Product Change Notice (PCN)

PCN Number: **PCN-0450884R-01**

Product(s) Affected: **PJ1-023-SMT-TR**

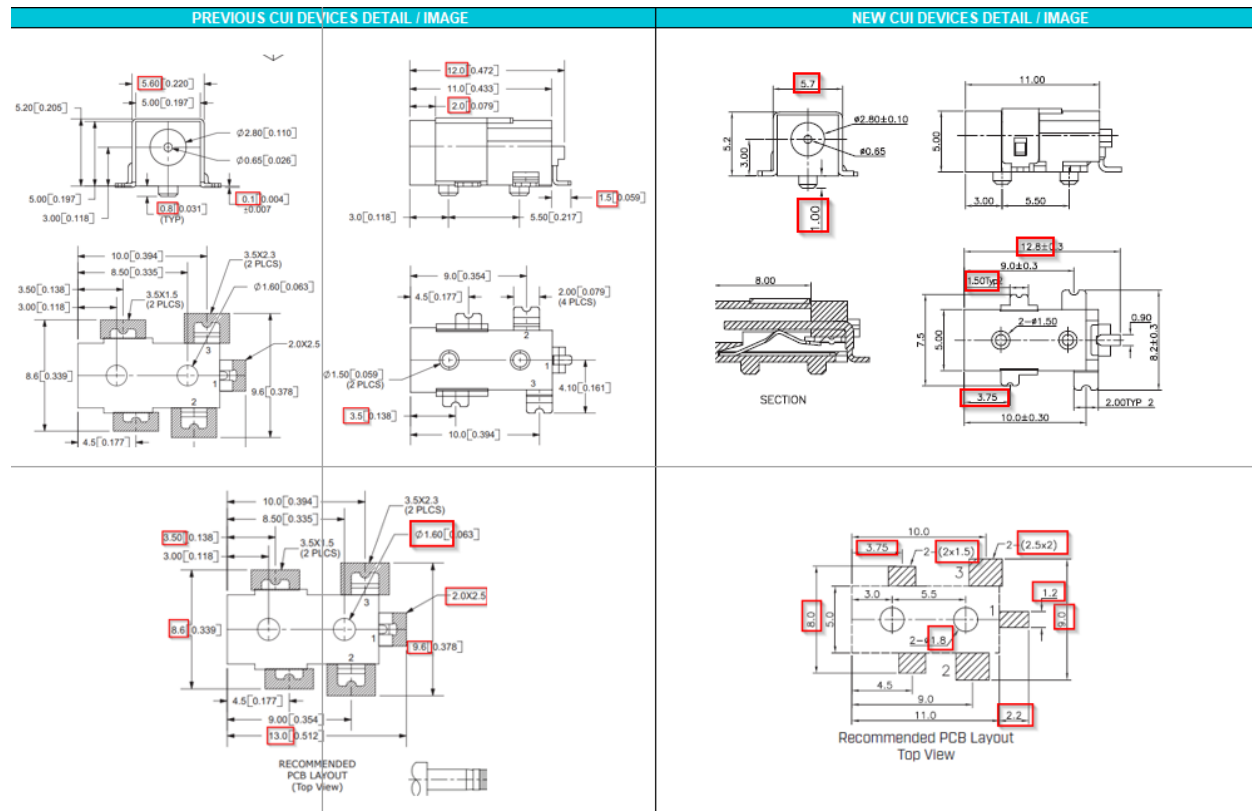
Description of Change: **Minor Housing and footprint differences. Material Change on the housing and terminals. See image Below**

| PREVIOUS CUI DEVICES DETAIL / IMAGE | | | NEW CUI DEVICES DETAIL / IMAGE | | |
|-------------------------------------|--------------------|---------|--------------------------------|----------------|---------------|
| center pin | brass | silver | center pin | brass | silver |
| terminal 1 | brass | silver | terminal 1 | brass | silver |
| terminal 2 | copper alloy | silver | terminal 2 | SUS301 t=0.25 | silver |
| terminal 3 | brass | silver | terminal 3 | brass t=0.40 | silver |
| shield | cold rolled steel | nickel | shield | brass t=0.40 | silver |
| plastic | PA6T or equivalent | | housing | PA9T (UL94V-0) | black |
